Access Compliance Report

Public Rights-of-Way

Intersection ID: 8181	Main Street: FREEDOM_DR	Cross Street: TODDVILLE_RD	Location:	N
ADA ID: 88A53C3180A2	Ramp Type: BlendTrans2	Initial Pass/Fail: Pass	Overall Compliance: No	Severity Score: 15.25

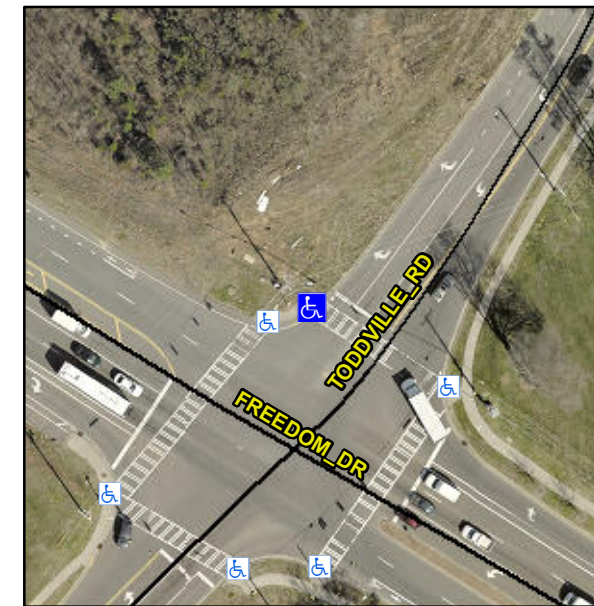
NO RT SW

R304.5.3, R305, R304.5.4

Compliance	Description	Data	Compliance	Description	Data
N/A	Ramp Length (in)	71.0	Yes	BlendTrans Slope (%)	0.9
Yes	Ramp Width (in)	68.0	No	BlendTrans XSlope (%)	3.9
N/A	Flare Type LT	None	N/A	Flare Type RT	None
N/A	Flare Slope LT (%)	N/A	N/A	Flare Slope RT (%)	N/A
N/A	Flare Traversable LT?	N/A	N/A	Flare Traversable RT?	N/A
N/A	Landing Length (in)	N/A	No	DWS Provided?	No
N/A	Landing Width (in)	N/A	N/A	DWS Contrast?	No
N/A	Landing Slope (%)	N/A	N/A	DWS Length (in)	N/A
N/A	Landing X Slope (%)	N/A	N/A	DWS Full Width?	No
N/A	Landing Curb? (Y/N)	No	N/A	DWS Offset (in)	N/A
N/A	Shared Landing?	No			
Yes	Gutter Ponding?	No	No	Gutter Slope (%)	5.4
Yes	Gutter Lip Ht (in)	0.0	No	Gutter X Slope (%)	3.2
N/A	Painted X Walk1?	Yes	N/A	Painted X Walk2?	N/A
	X Walk 1 Direction	To SE		X Walk 2 Direction	N/A
	X Walk 1 Width (in)	112.0		X Walk 2 Width (in)	N/A
	X Walk 1 Slope (%)	5.4		X Walk 2 Slope (%)	N/A
	X Walk 1 X Slope (%)	0.7		X Walk 2 X Slope (%)	N/A

Remove & Replace Curb Ramp With Two New Directional Ramps or Equivalent. Remove & Replace Gutter.
